DEVELOPMENT REVIEW BOARD REPORT

CASE NUMBER/
PROJECT NAME **67-DR-2005**
 Sandalo Townhomes

REQUEST Request approval of a site plan and elevations for a 6-building, 44-unit townhome development.

Stipulations for Case: Sandalo Townhomes Case 67-DR-2005

BUILDING A1 & A2

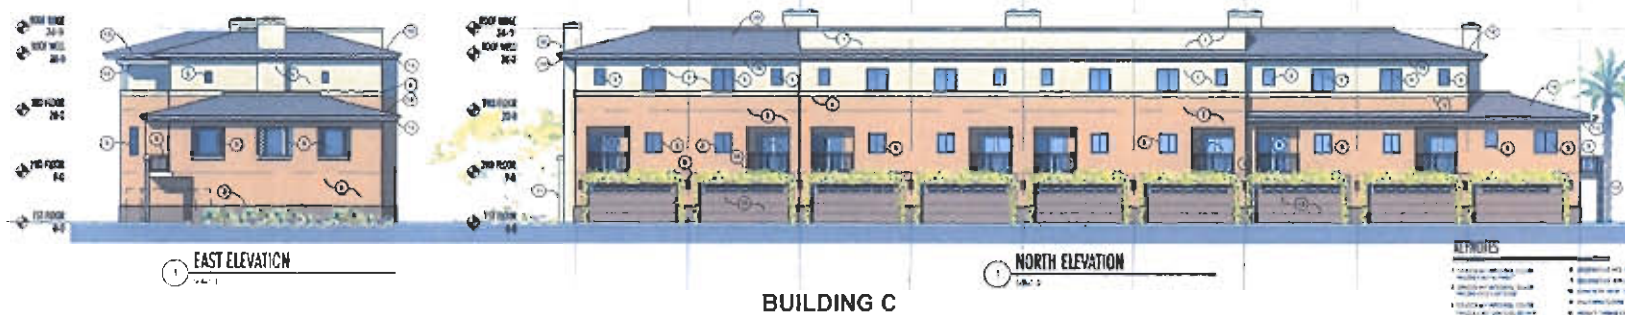
9. The fixture shown on the elevations must be replaced to comply with the lighting stipulations below.
10. Windows shall be recessed to 50% of wall depth measured from the external face of glazing to the external face of wall, excluding external detailing.
